SUBJECT: Forwards addl info re near-term completion of Item 4.3,
 "Reactor Trip Sys Reliability" of Generic Ltr 83-28 &
 addresses 13 items listed in final SER on shunt trip design.

Re: Docket No. 50-275, OL-DPR-76
Docket No. 50-323
Diablo Canyon Units 1 and 2
GL No. 83-28 - Generic Implications of ATWS Events
Item 4.3 "Reactor Trip System Reliability"

SHUNT TRIP MODIFICATION

8312280416-01 DC-663197-33-2

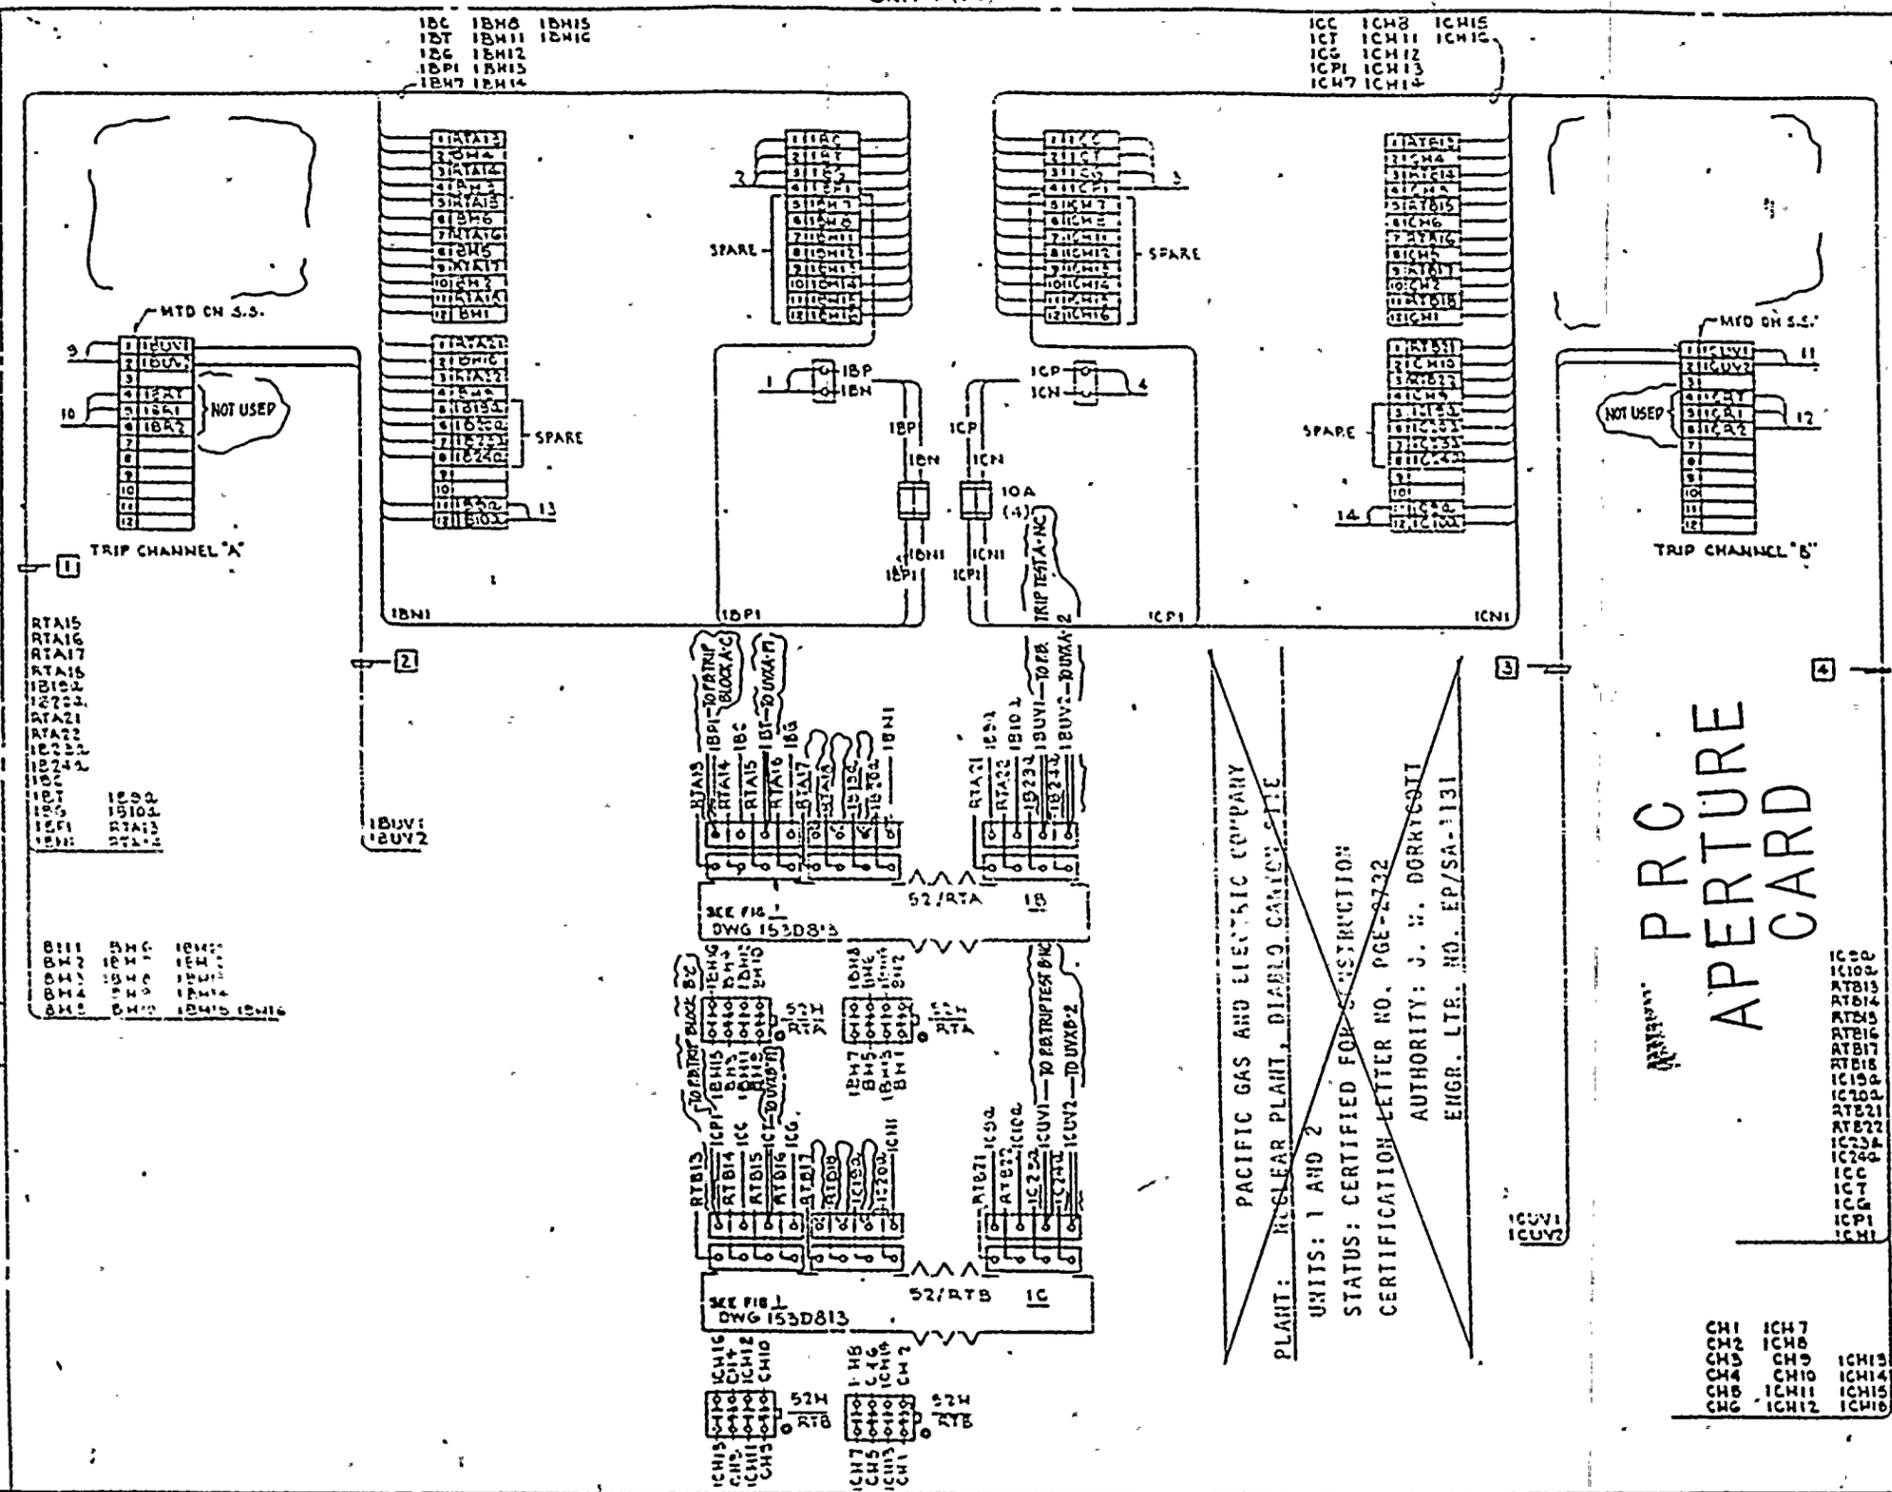
"Provide the electrical schematic/elementary diagrams for the reactor trip and bypass breakers showing the undervoltage and shunt coil actuation circuits as well as the breaker control (e.g., closing) circuits, and circuits providing breaker status information/alarms to the control room."

"Identify the power sources for the shunt trip coils. Verify that they are Class 1E and that all components providing power to the shunt trip circuitry are Class 1E and that any faults within non-Class 1E circuitry will not degrade the shunt trip function. Describe the annunciation/indication provided in the control room upon loss of power to the shunt trip circuits. Also describe the overvoltage protection and/or alarms provided to prevent or alert the operator(s) to an overvoltage condition that could affect both the UV coil and the parallel shunt trip actuation relay."

Attached are electrical drawings for the reactor trip and bypass breakers showing the undervoltage and shunt coil actuation circuits as well as the breaker control (e.g., closing) circuits, and circuits providing breaker status information/alarms to the control room.

The power supplies and all components providing power to the shunt trip circuitry are Class 1E. No change has been made to the power supply portion of the circuitry. Drawing No. SK437610 Rev. 9B shows the power supply for the shunt trip coil of 52/RTA is from Battery 11 thru CKT 129D. The power supply for 52/RTB is from Battery 12 via CKT 229D. Since the Class 1E circuitry provided to the shunt trip is separated from non-Class 1E circuitry, a fault within non-Class 1E circuitry will not degrade the shunt trip function.
